MIL-C-17588E(SH)
 AMENDMENT 5
24 June 1993
 SUPERSEDING
 AMENDMENT 4
 5 July 1988

MILITARY SPECIFICATION

CIRCUIT BREAKERS (AUTOMATIC - ALB-1) AND SWITCH, TOGGLE
 (CIRCUIT BREAKER, NON-AUTOMATIC - NLB-1) AIR, INSULATED HOUSING,
 125 VOLTS AND BELOW, A.C. AND D.C., (NAVAL SHIPBOARD USE)

1B. Outline dimensions for mounting bases for one circuit breakers,
(Type MB-SP)
FIGURE 1. Type ALB-1 thermal-magnetic, enclosed, trip free (single pole)
and type NLB-1, switch, toggle (nonautomatic). - Continued

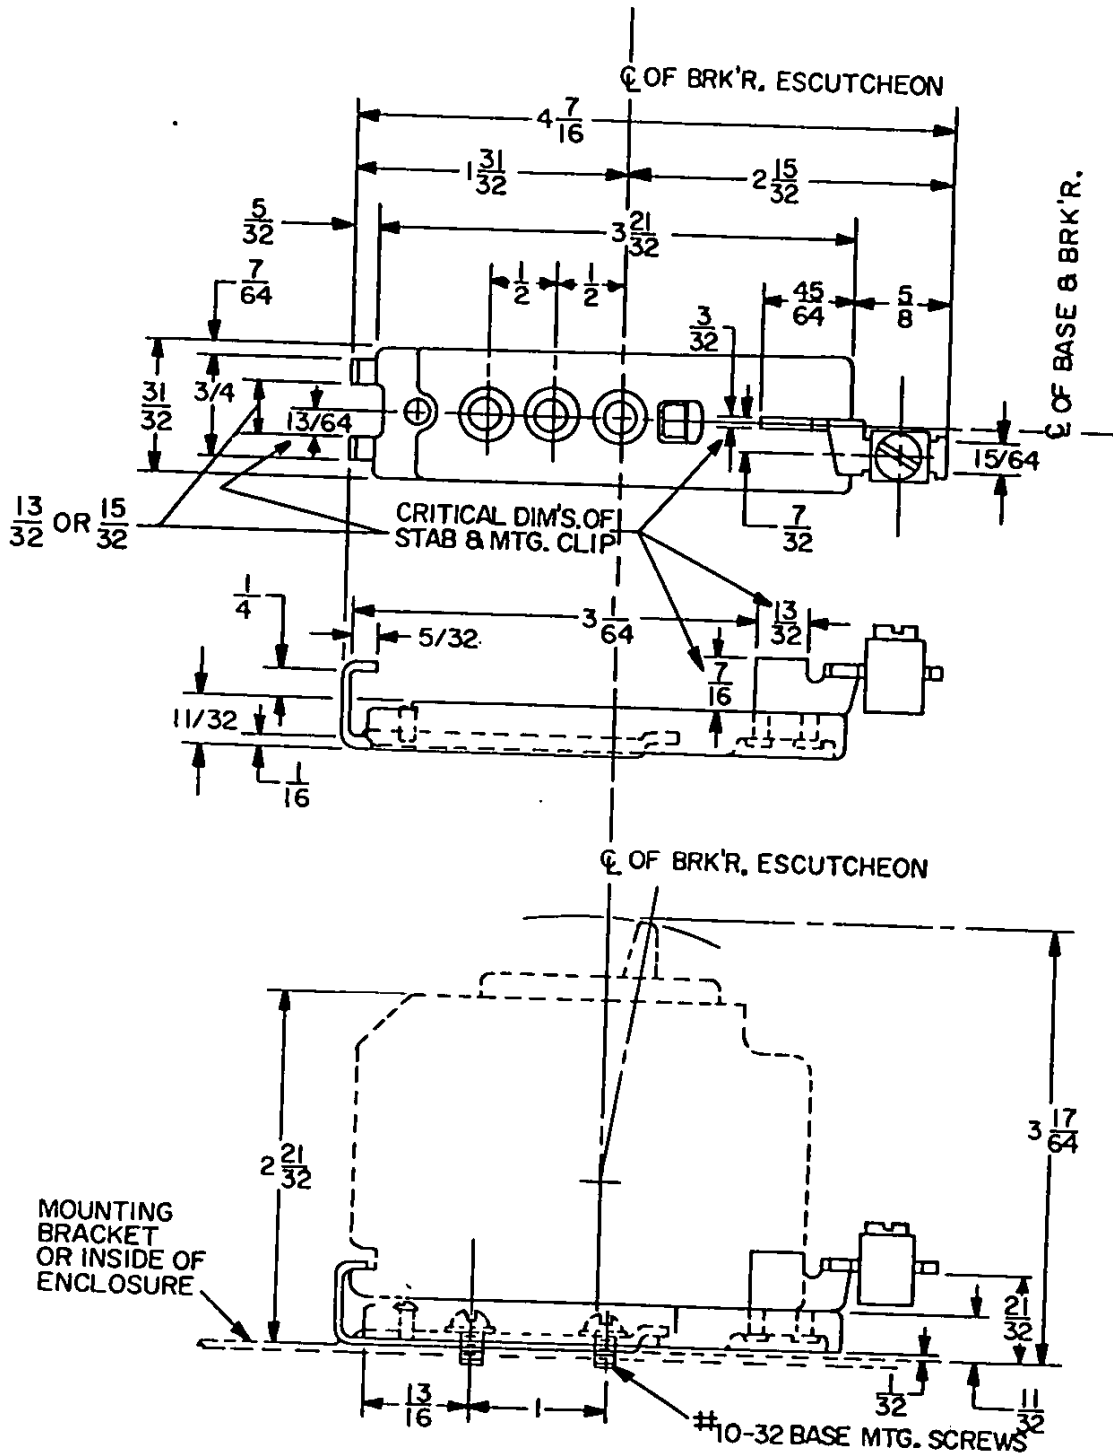
- * Figure 1: Delete and substitute attached figure 1B.

1C. Outline dimensions for mounting bases for two circuit breakers.
(Type MB-TP)

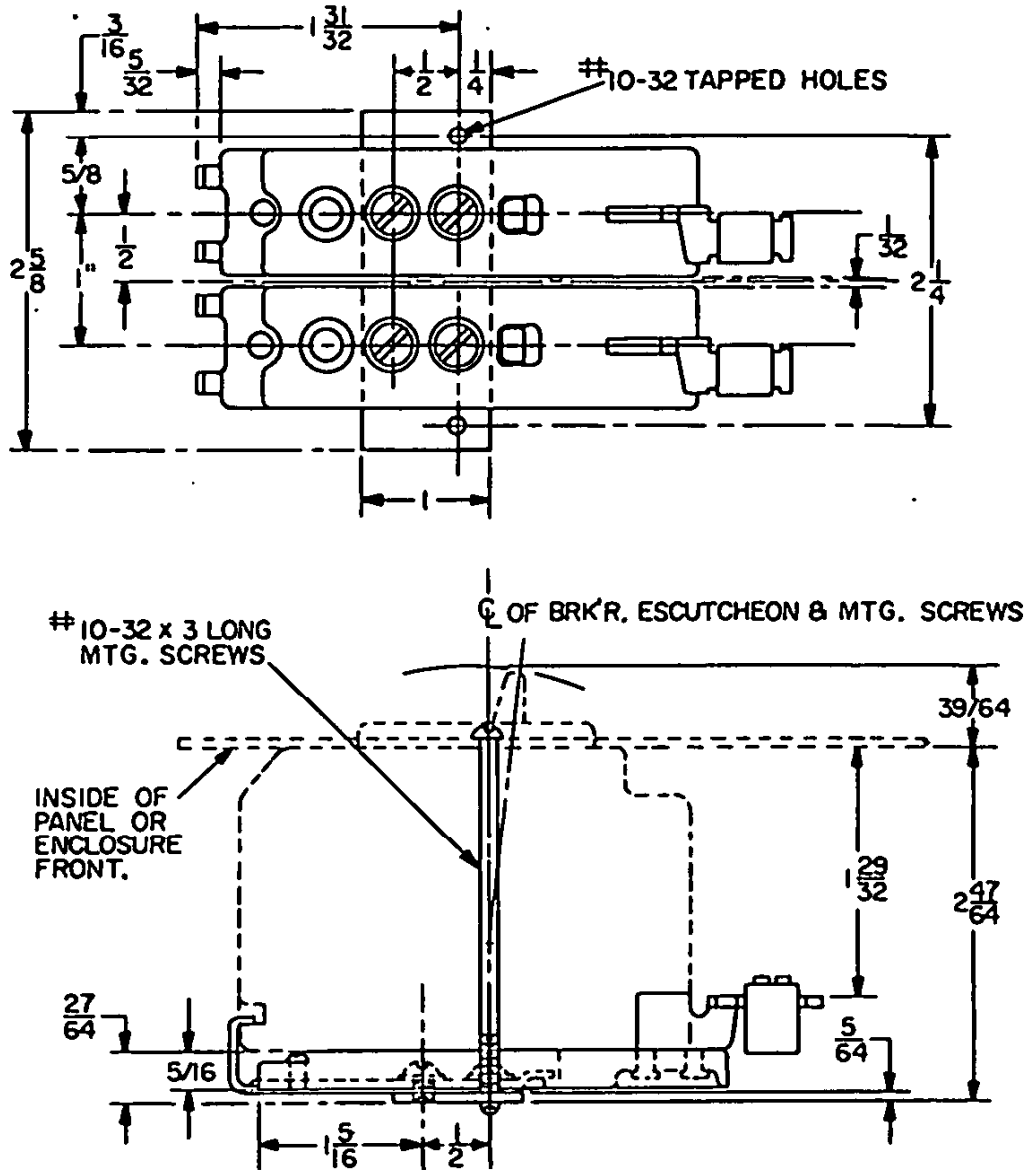
- * Figure 1: Delete and substituted attached figure 1C.

1D. Outline dimensions for mounting bases for circuit breakers

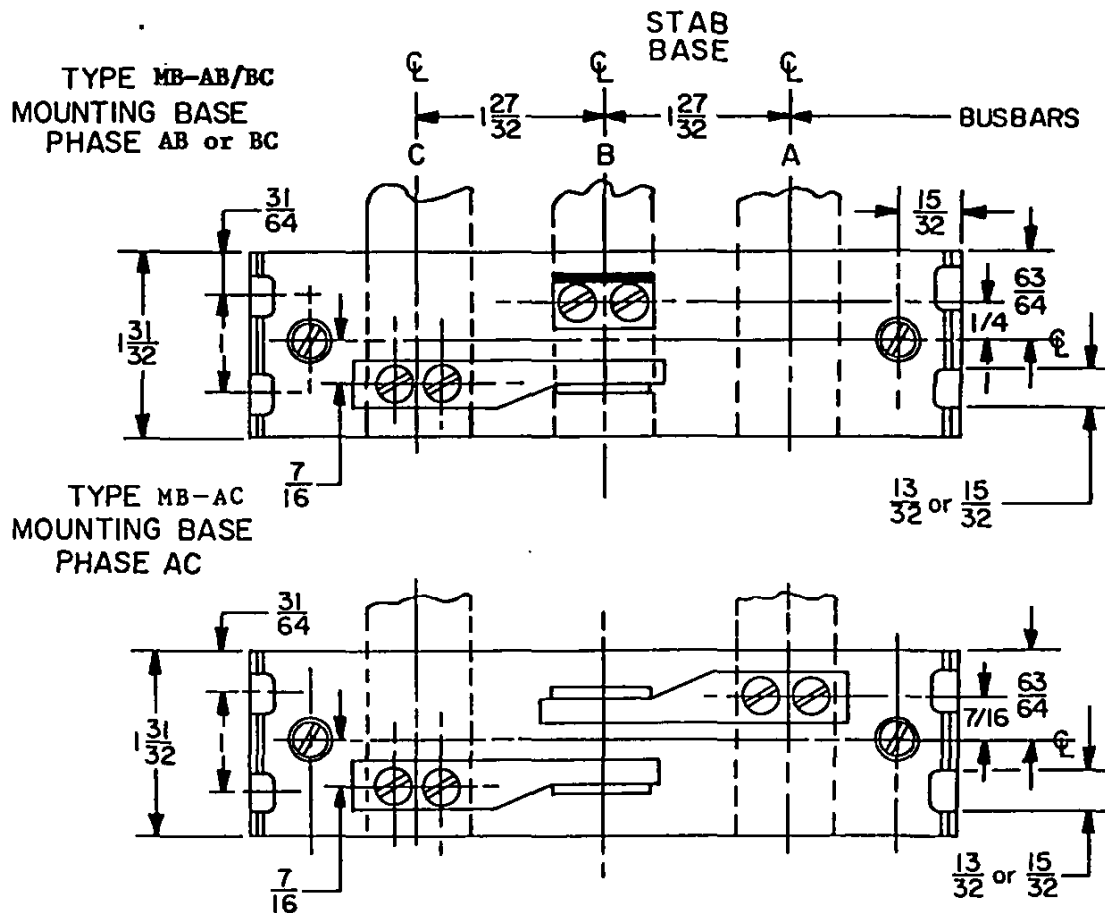
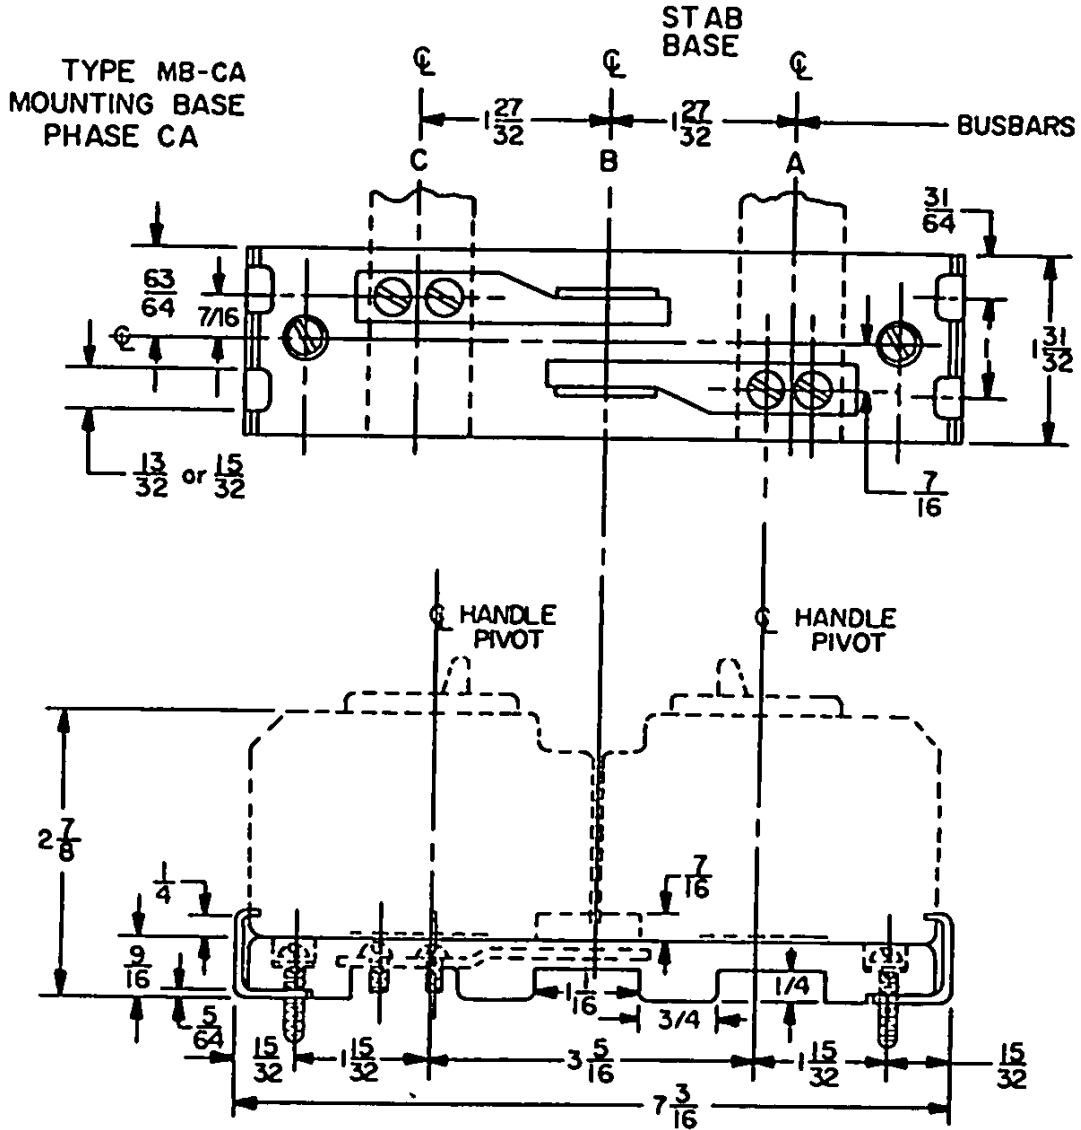
- * Figure 1: Delete and substitute attached figure 1D (pages 10, 11 and 12).
